CALL NO. 200
CONTRACT ID NO.
131212 Addendum # 2

Subject: Marshall Trigg County, 121GR13D012 - NHPP 0801 (098)
Letting December 20, 2013

- (1) Revised - Plan Sheets - R2, S2, S134, S183, S184A, S184B, S187, S192, S194, S206, S207, S207A, S207B, S208, S208A, S208B, S209, S209A, S210, S211, S212, S213, S216, S217, S260, S261, S274
- (2) Revised - Cover Page - PAGE 1 of 403
- (3) Revised - Completion Dates - Page 4 of 403
- (4) Revised - Multiple Notes - Various Pages
- (5) Revised - Bid Items - Page 397-403 of 403
- (6) Delete - Pages 27thru44, 216thru233, 207thru215, 234thru238 of 403

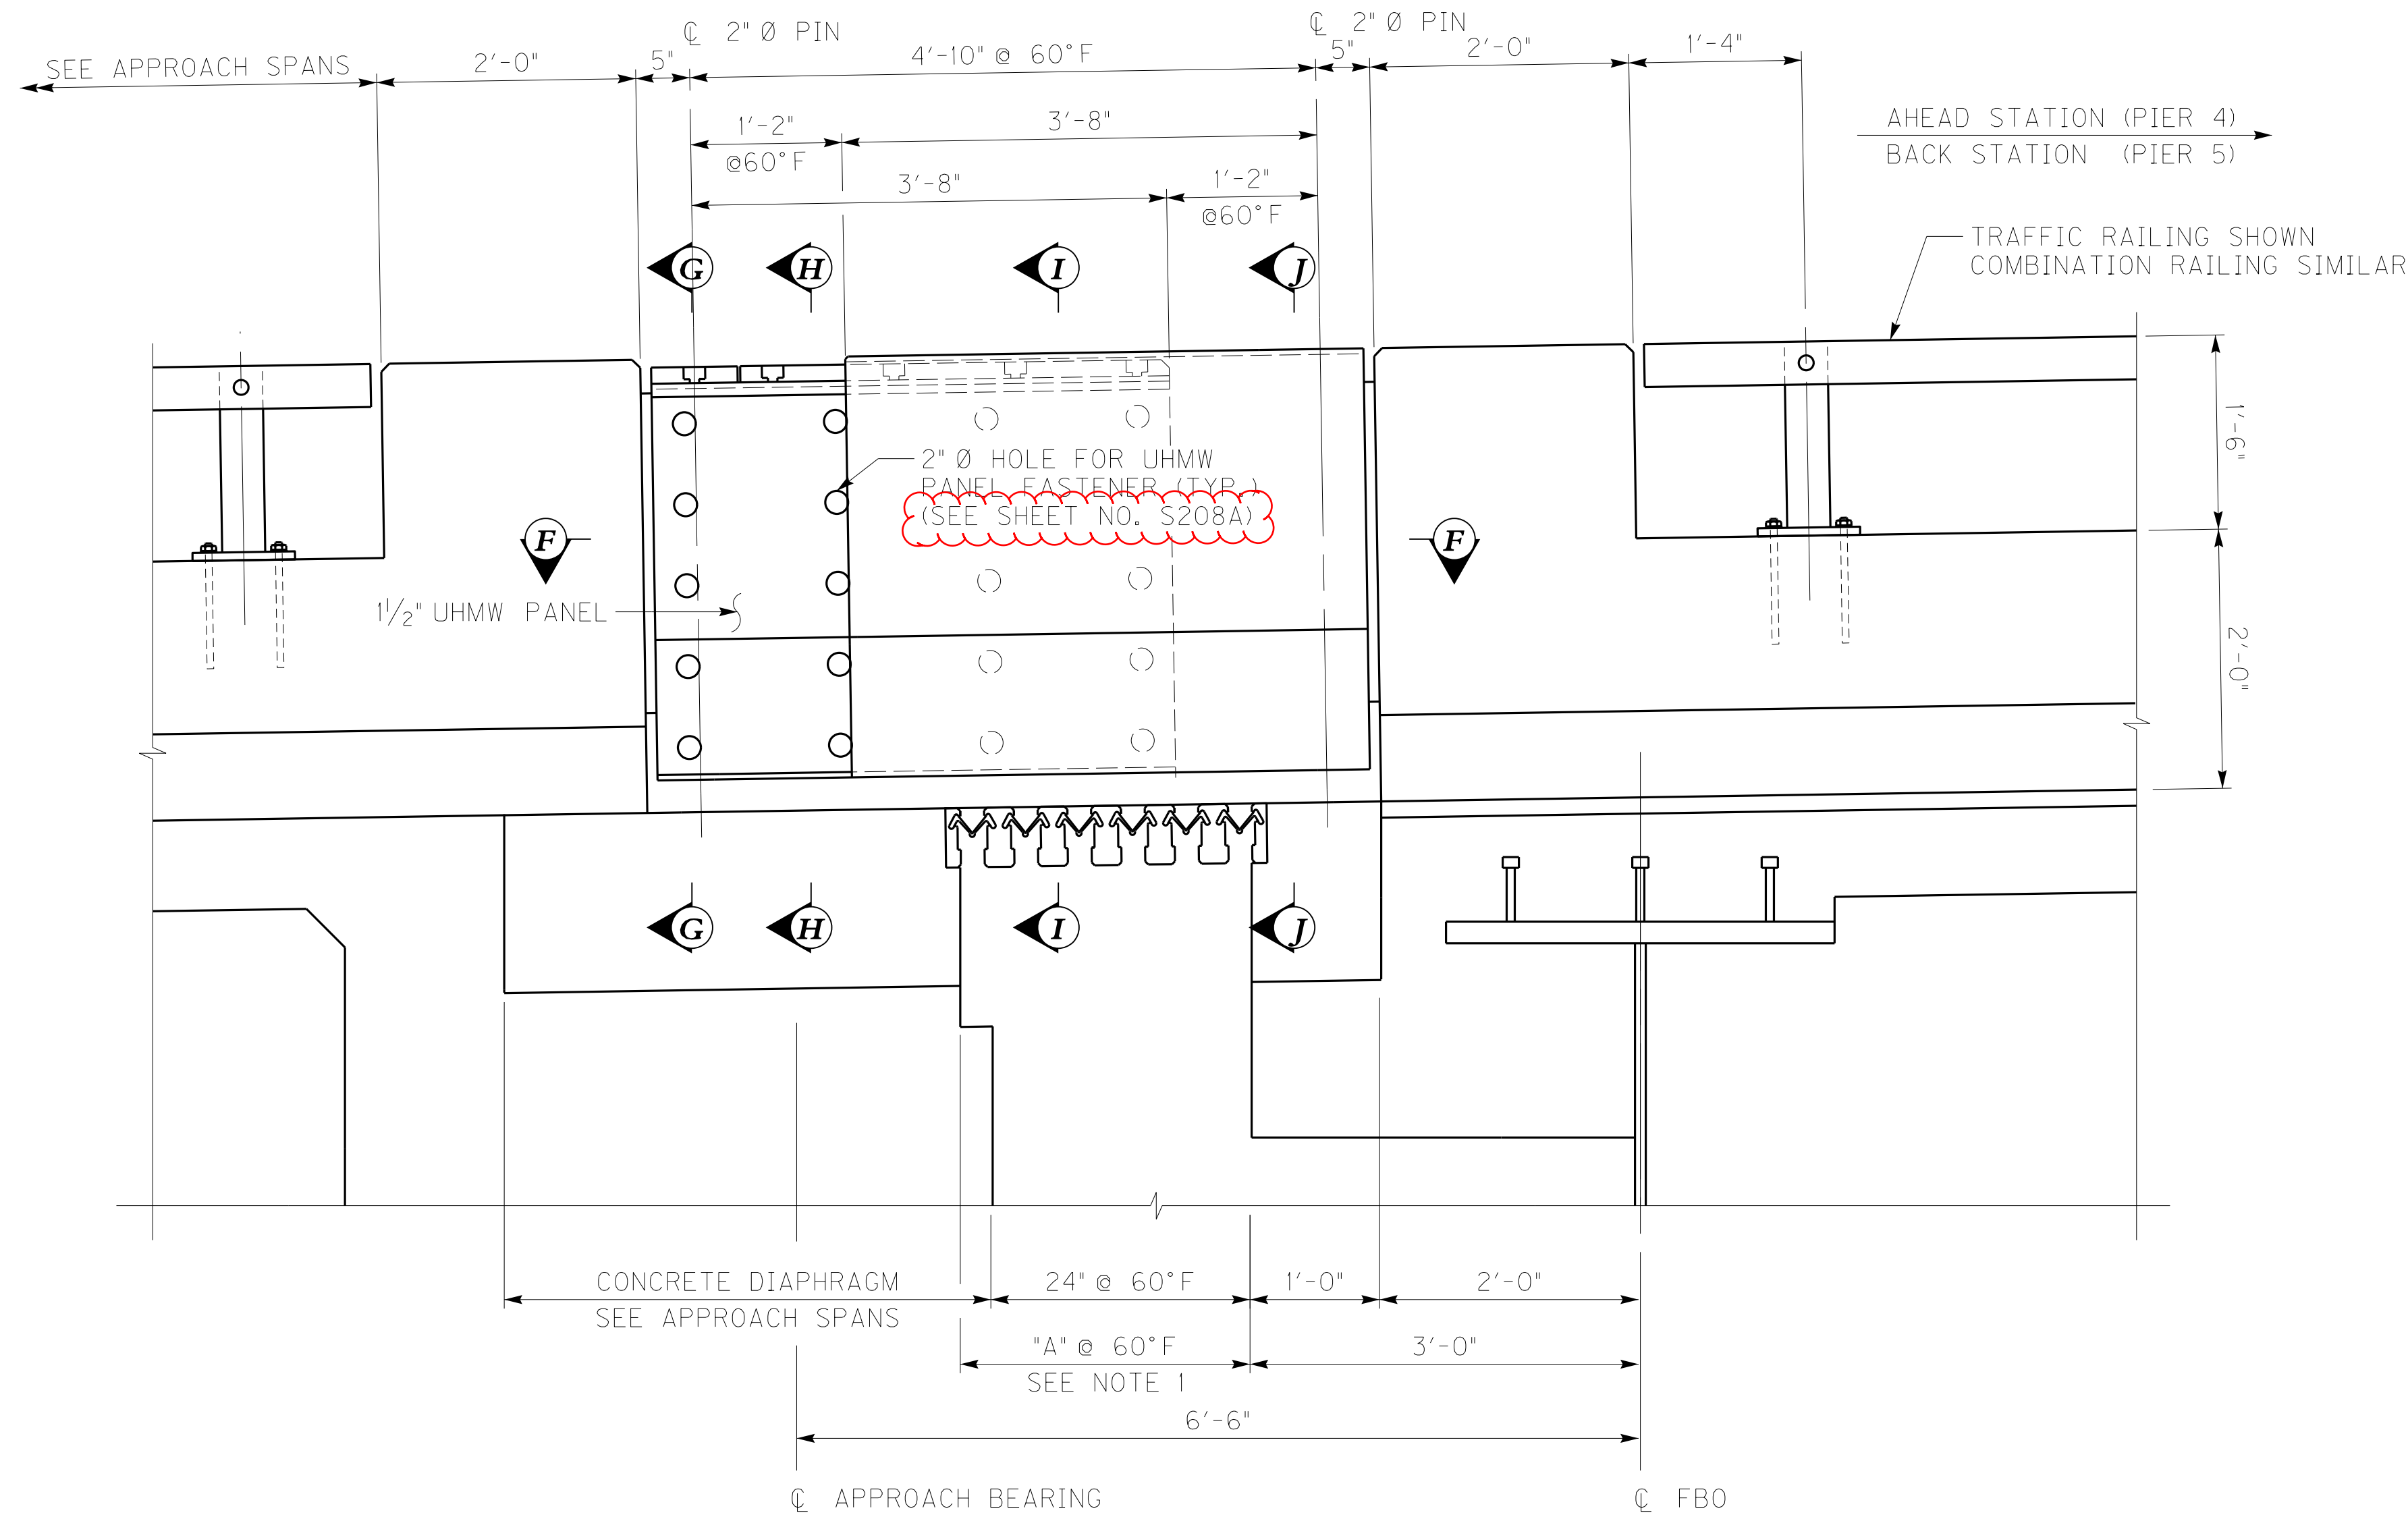
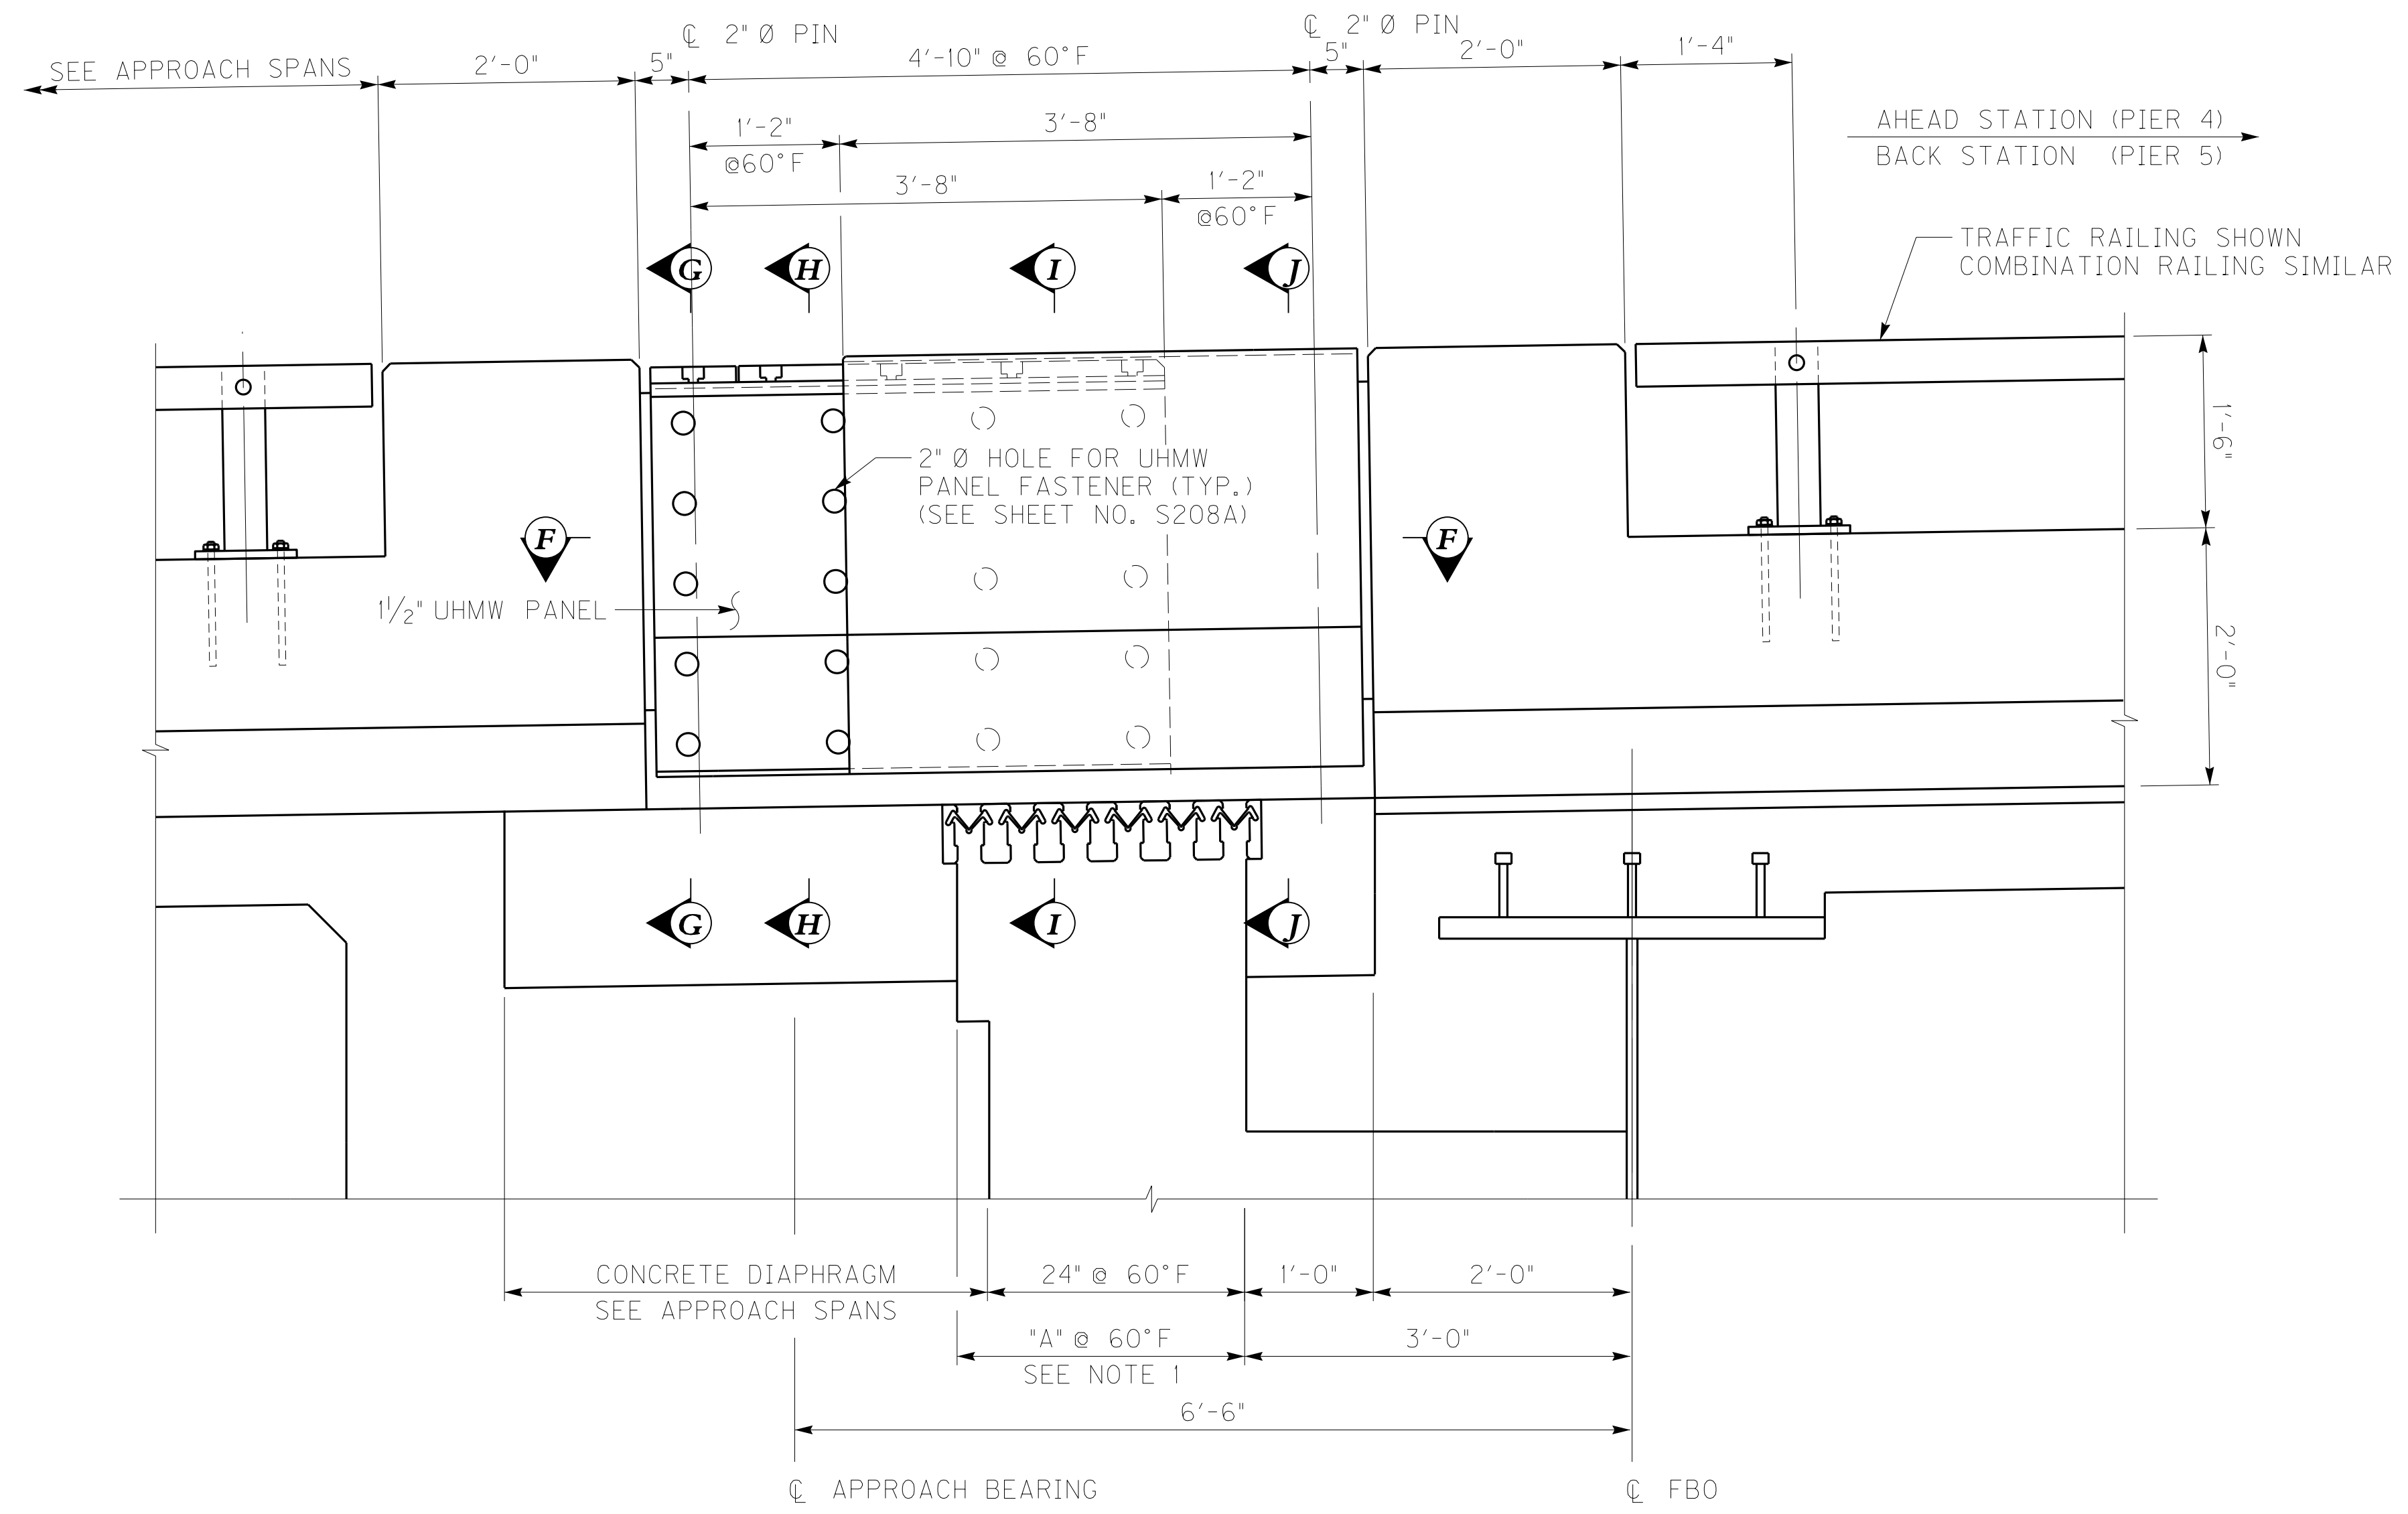
ADD CURB, ADD SHEET REF.		11/25/13
REVISION		DATE
DATE: NOVEMBER 15, 2013	CHECKED BY	
DESIGNED BY: DMB	TJT	
DETAILED BY: MJD	DMB	
Commonwealth of Kentucky DEPARTMENT OF HIGHWAYS		
COUNTY MARSHALL / TRIGG		
ROUTE US68	CROSSING KENTUCKY LAKE	
MODULAR EXP. JOINT DETAILS - 1		
PREPARED BY	MICHAEL BAKER JR., INC. 9750 ORMSBY STATION ROAD SUITE 210 LOUISVILLE, KY 40223	SHEET NO. S207 DRAWING NO. 24686
Baker
